PD Modification Application: PRS 22-0850

BOCC Land Use Meeting Date: July 26, 2022

1.0 APPLICATION SUMMARY

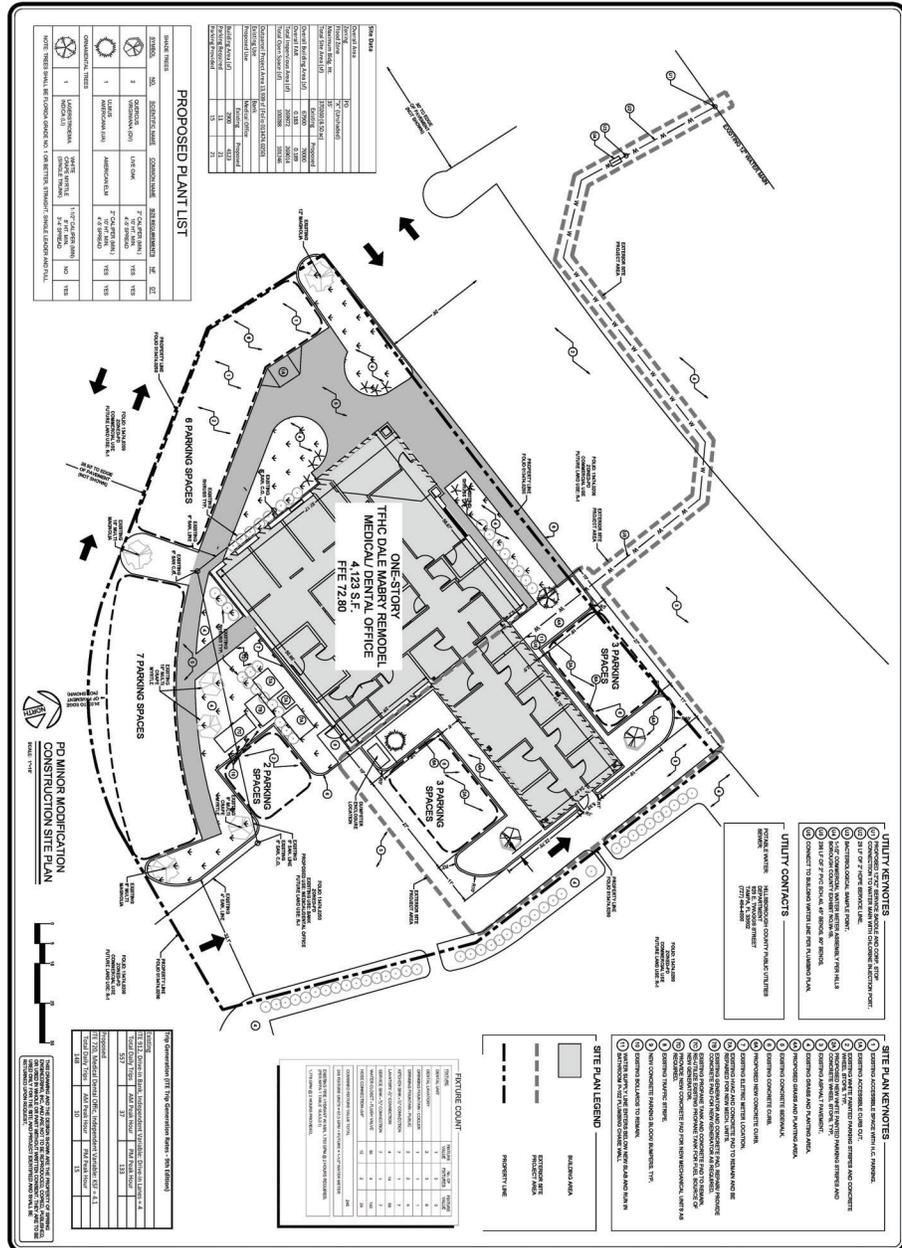
3. Show and label the existing sidewalk within the FDOT frontage road right-of-way (generally depicted by that portion of the yellow line east of the drive aisle, as shown in the graphic below);

4. Show and label the proposed sidewalks and crosswalks required pursuant to the above proposed conditions, (as generally depicted by the red lines below, although staff notes a portion of the required crosswalk is also shown in yellow where it overlaps the drive aisle); and,

5. Show and label the future pedestrian and vehicular access/cross access to the west, and label as "Future Pedestrian and Vehicular Access/ Cross Access – By Others". The pedestrian connection is generally represented by the green line shown below (and the required vehicular connection to the adjacent PD is anticipated to align with the drive aisle within the subject PD).

CONDITIONS OF APPROVAL

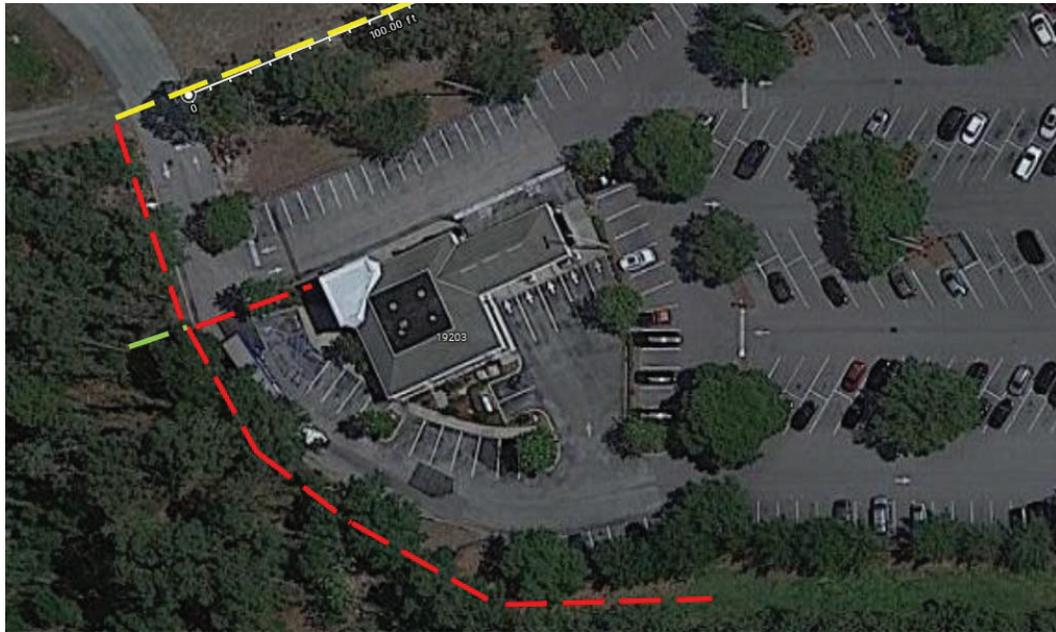
- Prior to PD site plan certification, the developer shall revise the PD site plan to:
 - Show the entire PD boundary and layout in the vicinity of the northwest project access and within those portions where the sidewalk required pursuant to the above proposed conditions as necessary;
 - Show and label the existing sidewalk within the FDOT frontage road right-of-way (generally depicted by that portion of the yellow line east of the drive aisle, as shown in the graphic below);
 - Show and label the proposed sidewalks and crosswalks required pursuant to the above proposed conditions, (as generally depicted by the red lines below, although staff notes a portion of the required crosswalk is also shown in yellow where it overlaps the drive aisle); and,

- Show and label the future pedestrian and vehicular access/cross access to the west, and label as “Future Pedestrian and Vehicular Access/ Cross Access – By Others”. The pedestrian connection is generally represented by the green line shown below (and the required vehicular connection to the adjacent PD is anticipated to align with the drive aisle within the subject PD).
